**PARKING ACCESS AND REVENUE CONTROL SYSTEM
RFP#15-10-15**

QUESTIONS AND ANSWERS

June 18, 2015

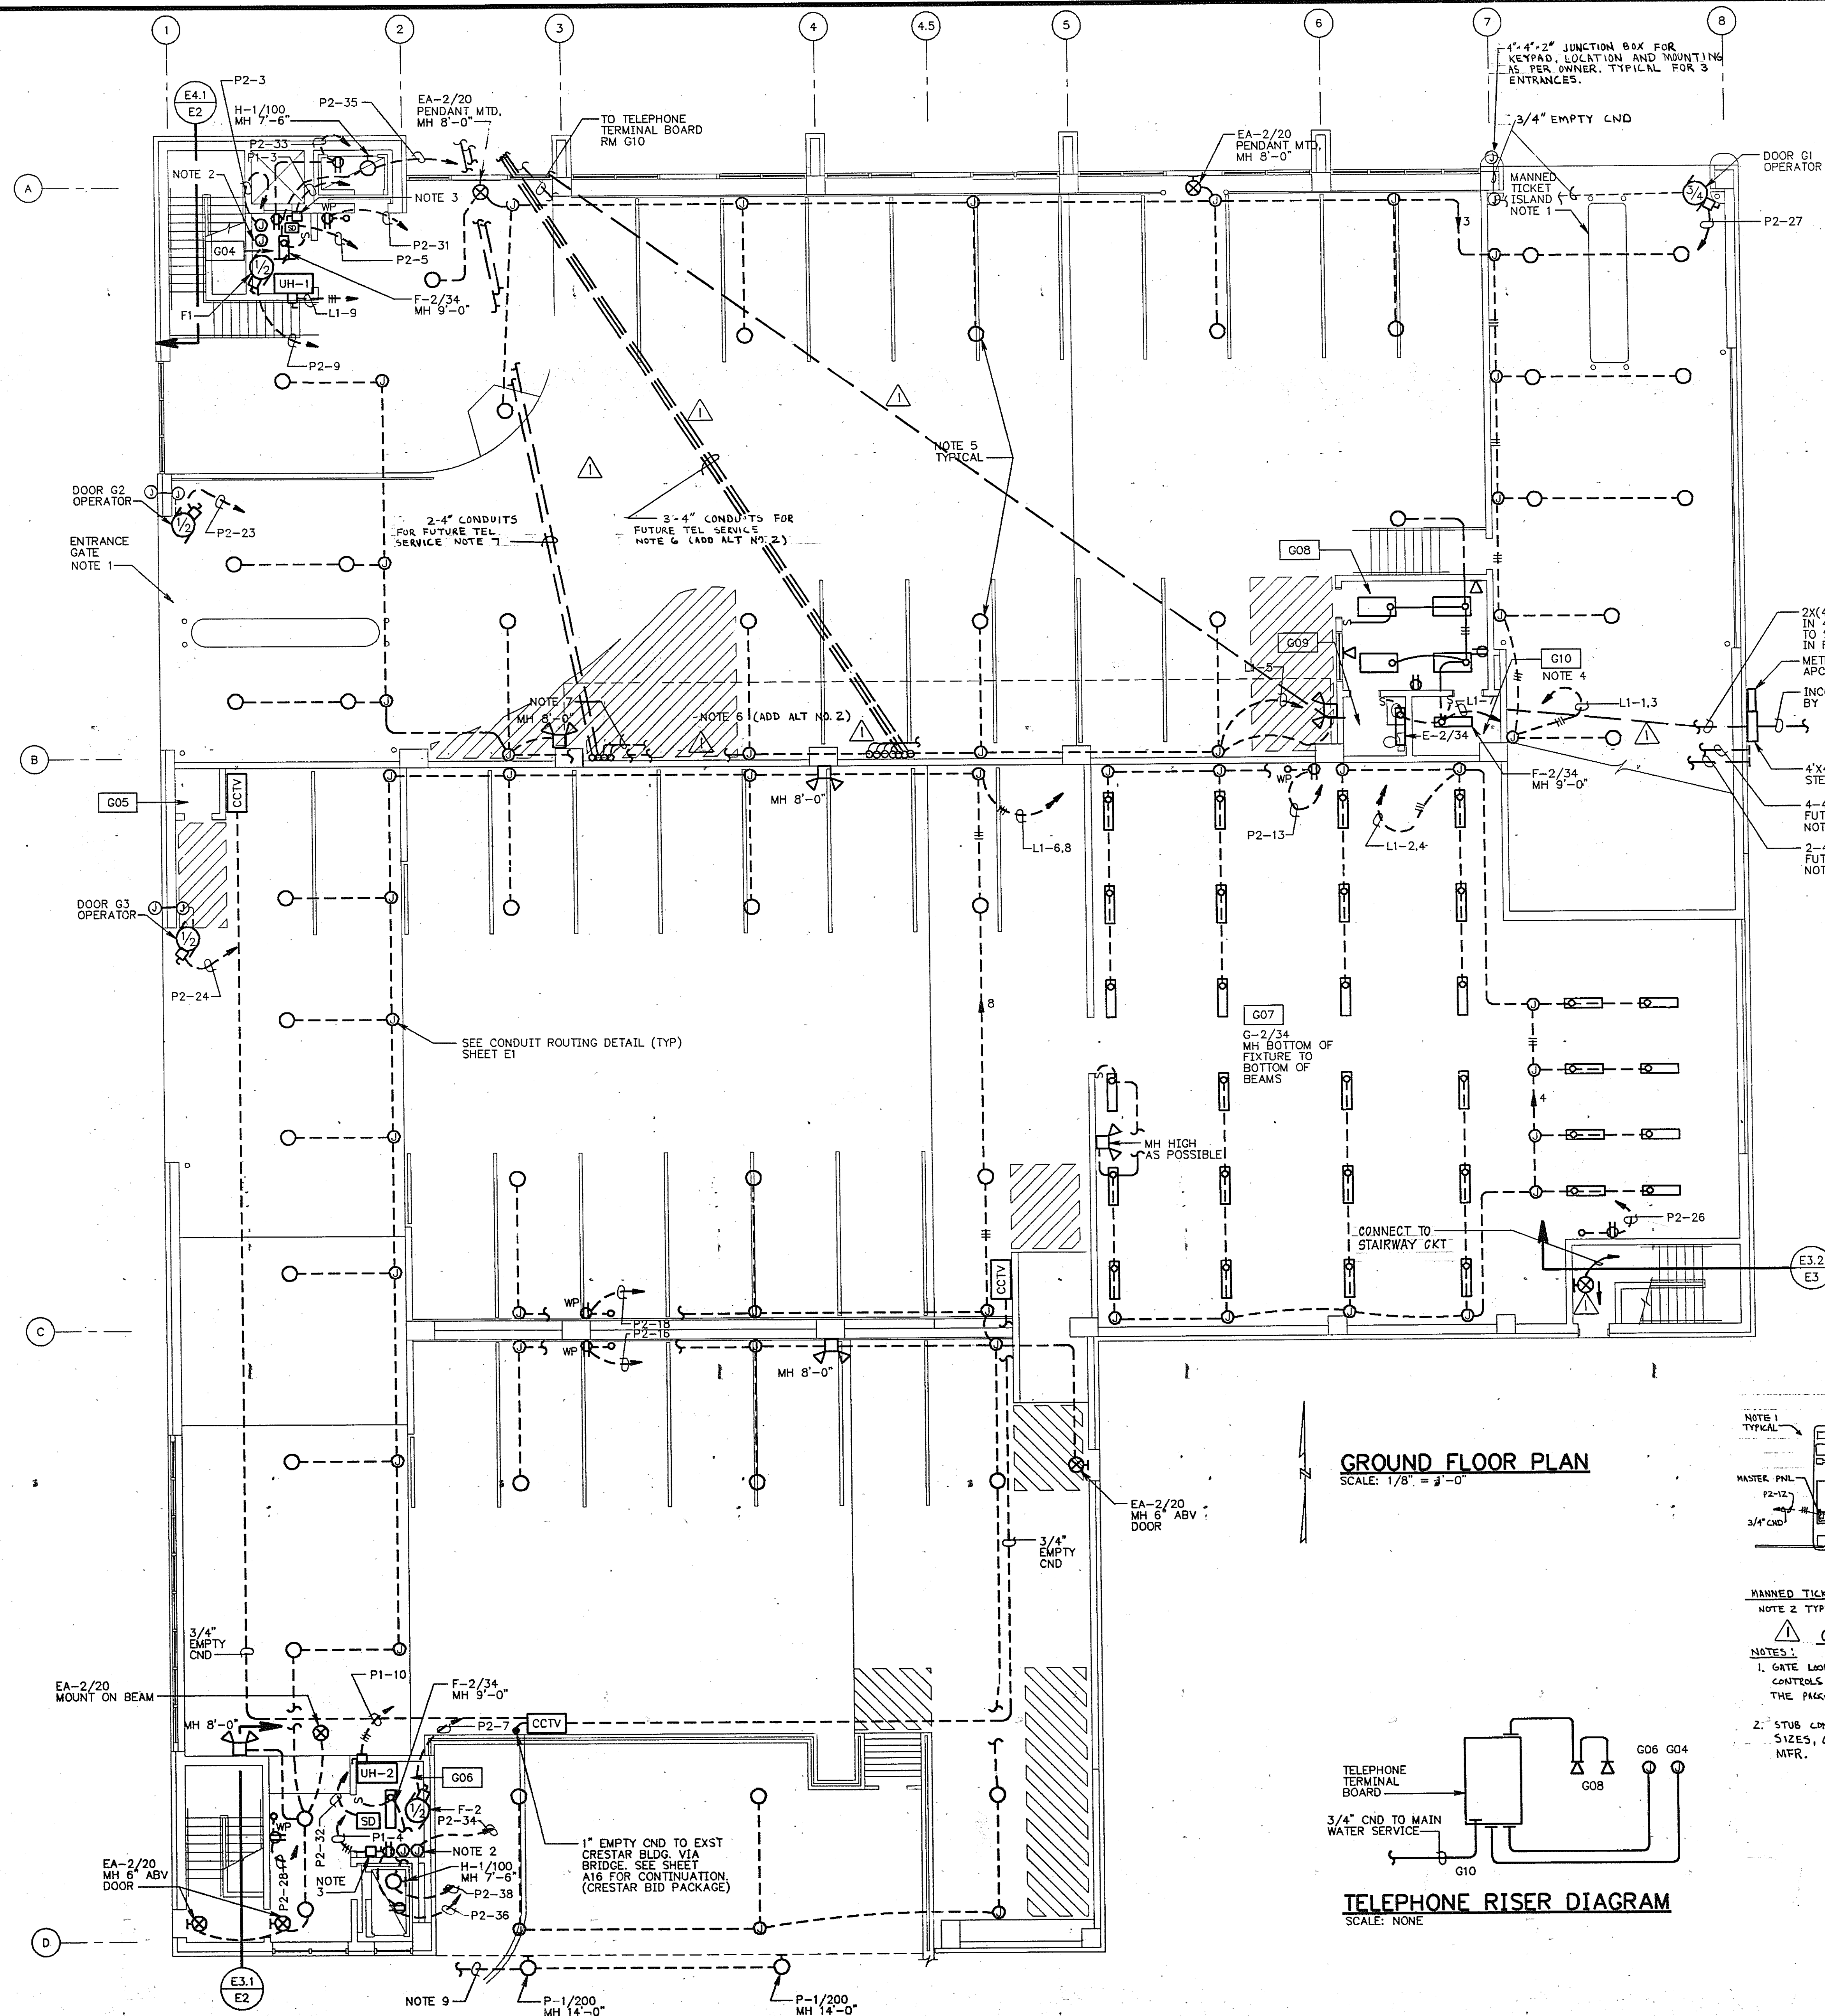
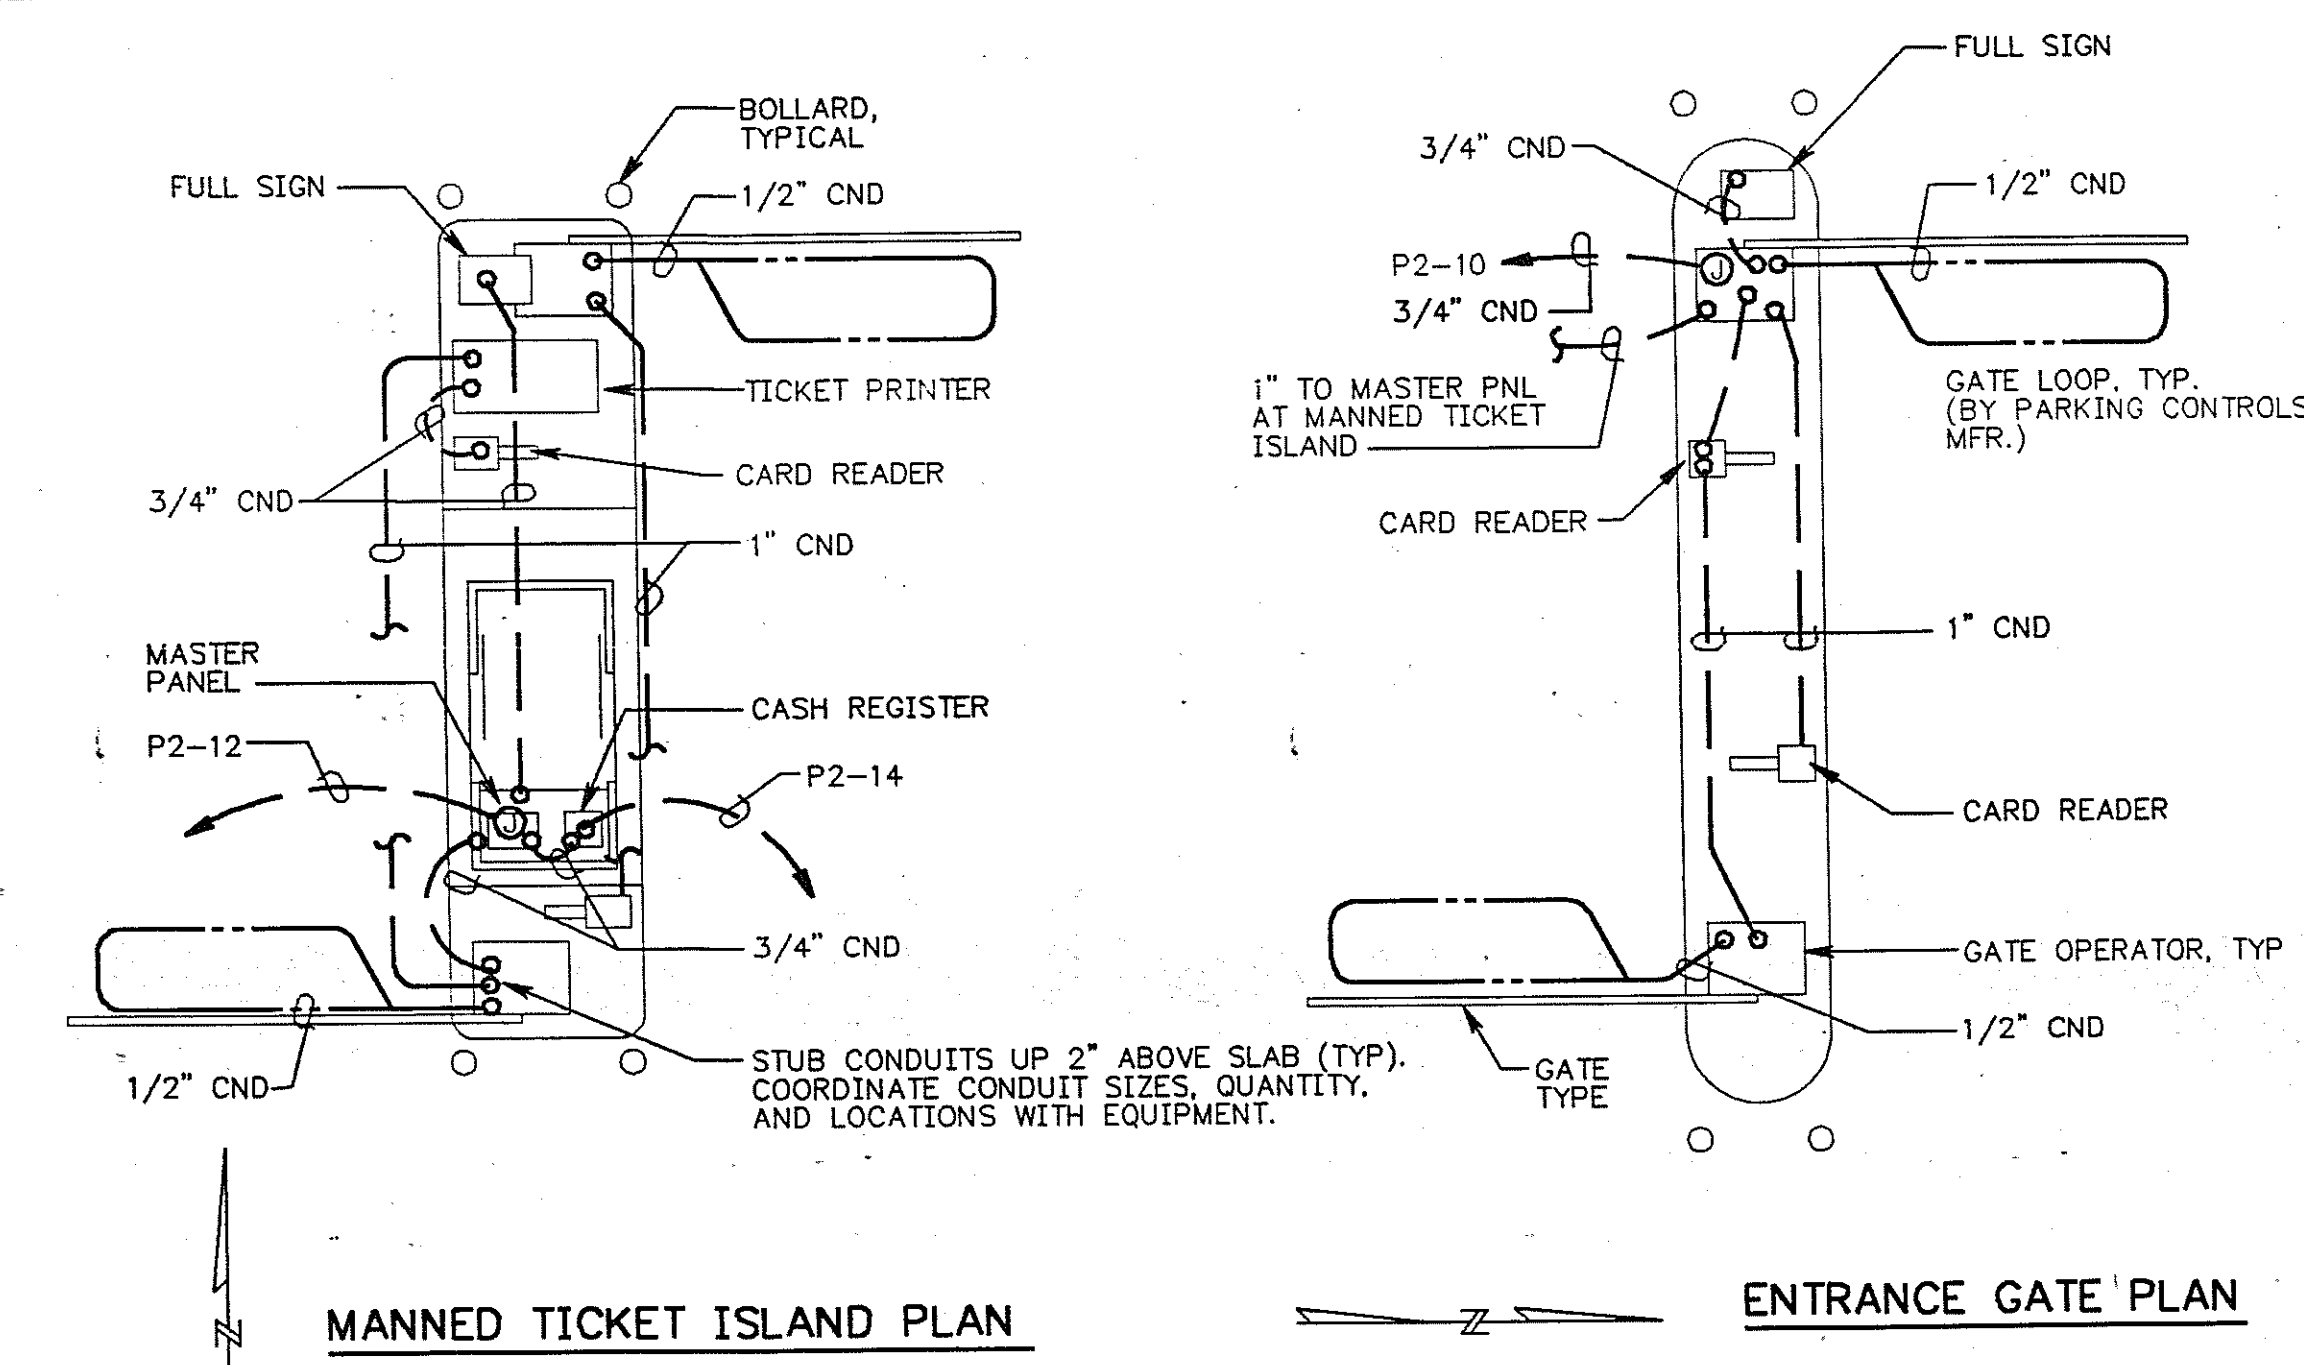
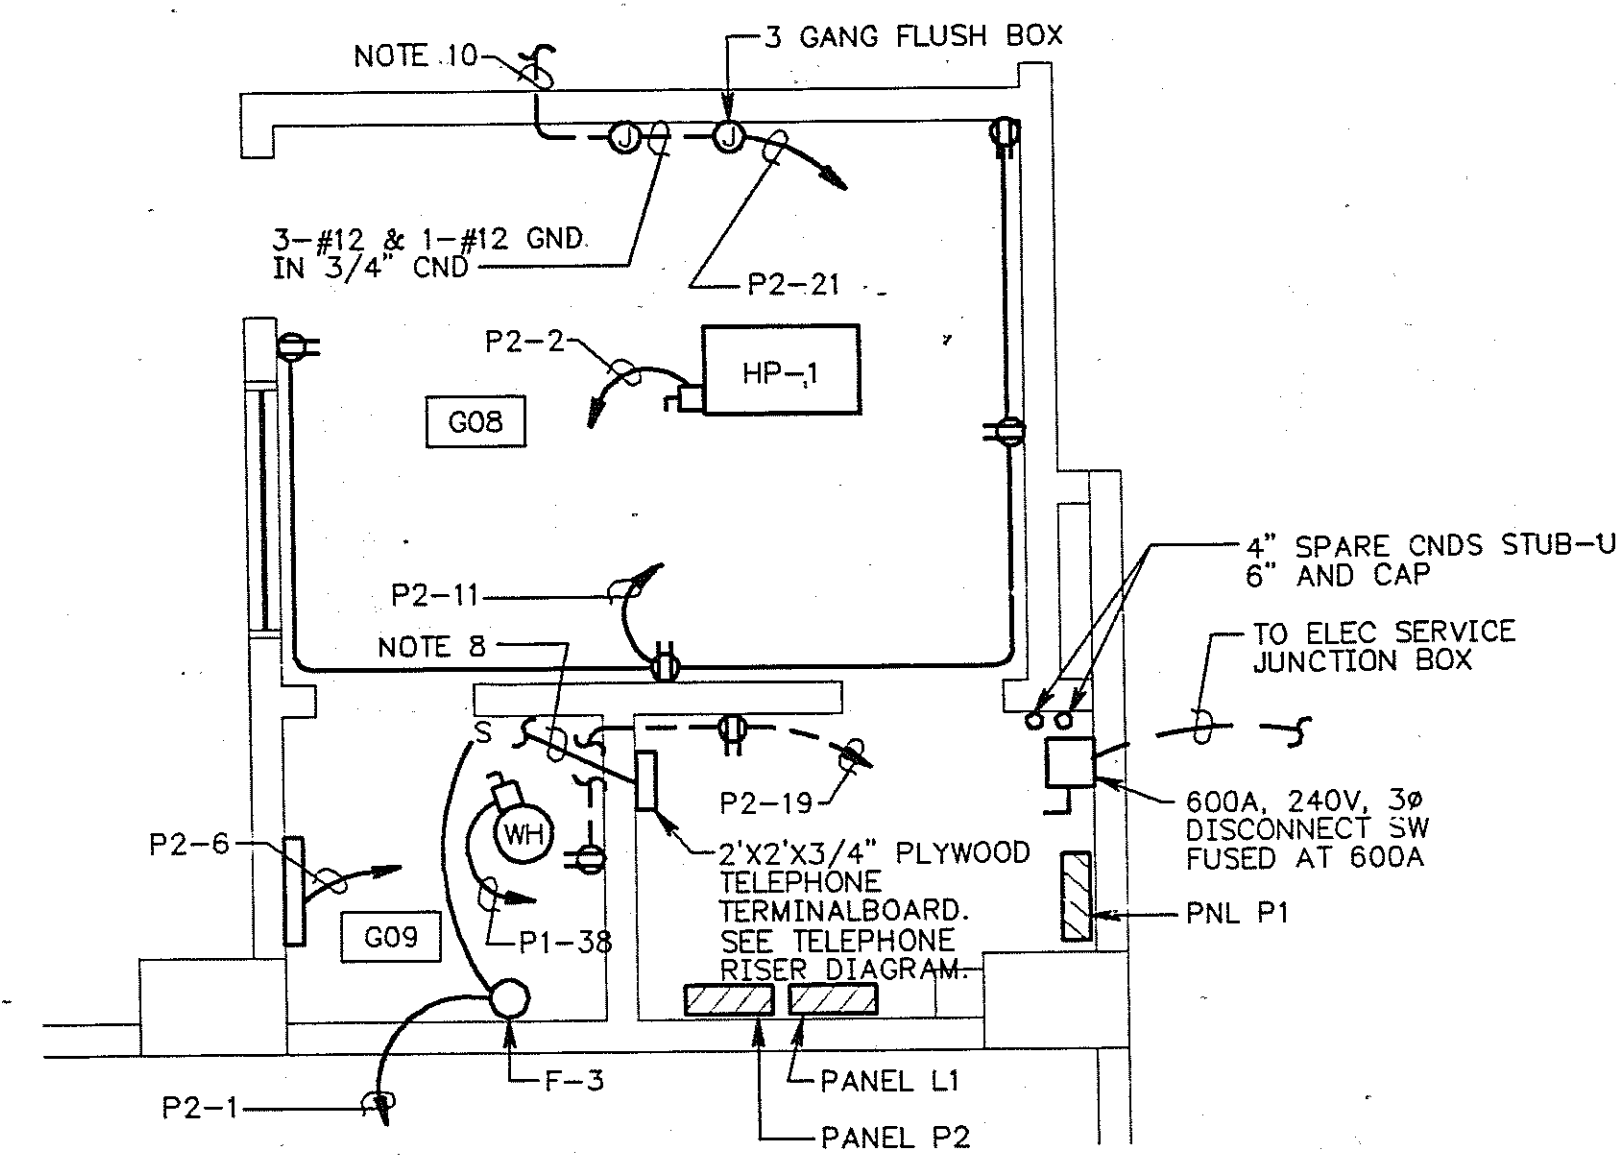
1. Would there be a place to find the addresses of all parking locations?
A. <http://parkroanoke.com/wp-content/uploads/PARK-Roanoke-Map-20151.jpg>
2. Do you have plans for the Market Garage facility showing conduit?
A. **Please see attached plan.**
3. Will the hotel need access to operate the gate from the front desk remotely?
A. **Yes.**
